**ADDENDUM ONE**  
**QUESTIONS and ANSWERS**  
**6652 OF**

RE: Addendum for Invitation to Bid (ITB) Number 6652 OF for Hydraulically Reversible, Trip Edge, Snow Plows with Twelve Foot Steel Moldboard & Twelve Foot Polymer Moldboard to be opened on February 18, 2022 at 2:00 p.m. Central Time

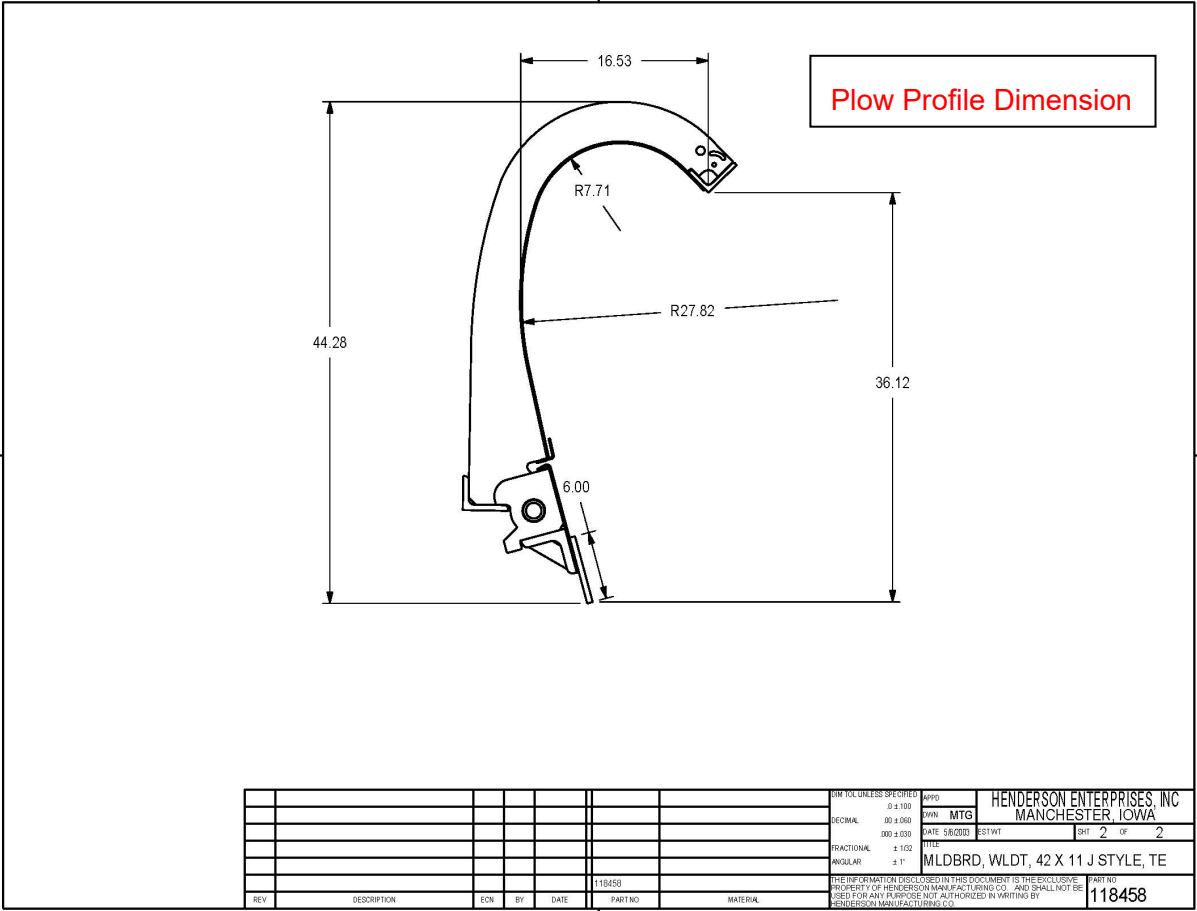
<u>Question Number</u>	<u>ITB Section Reference</u>	<u>ITB Page Number</u>	<u>Question</u>	<u>State Response</u>
1	C2	Design of J-style per drawing	Would Nebraska accept Henderson design of J-style plow as depicted in drawing Plow Profile Dimension?	Bid as per NDOT supplied drawing.
2	C7	One piece trip edge with six adjustable torsion springs.	Would Nebraska accept Henderson 5 springs?	Bid as per specification Section C7
3	C8	Springs shall be from not less than 3/4" square wire, having a 3-3/4" O.D. with fifteen active coils each	Would Nebraska accept Henderson spring as per attached drawing 95297PROPOSAL?	Yes, and long as they meet the quantity in section C7
4	C11	Spring shaft shall be solid rod.	Would Nebraska accept a tube of 1875 OD x .25 W in lieu of the solid rod?	Bid as per specification written in C11
5	C23	Moldboard must have ten 1/2 inch one piece steel reinforcing ribs.	Would Nebraska accept eight 1/2 inch ribs?	Bid as per specification written C23

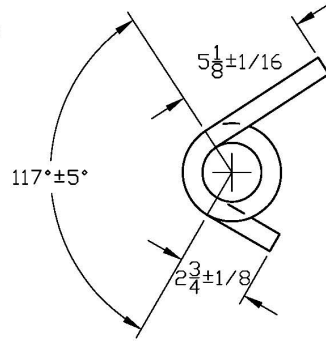
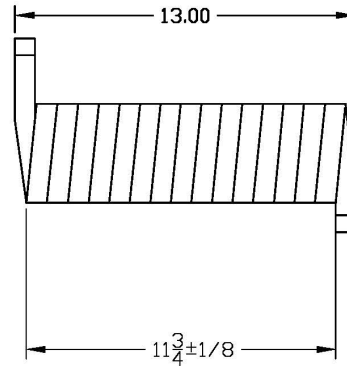
6	D4 and D5	Polymer sheet to have a minimum tensile strength of 7,000 PSI. Sheet to be of ultra-high molecular weight polyethylene.	Would Nebraska accept Very-High molecular weight poly with a tensile strength of 35,000 PSI?	Bid as per specification in section D4 & D5
7	F4	...and shall include two moldboard braces made from two inch square tubing with 1-1/8 inch diameter attaching pins...	Would Nebraska accept three moldboard braces made of 1/2"x 3/4" x 2" bar welded braces per the attached picture Moldboard Braces?	Yes, this is acceptable.
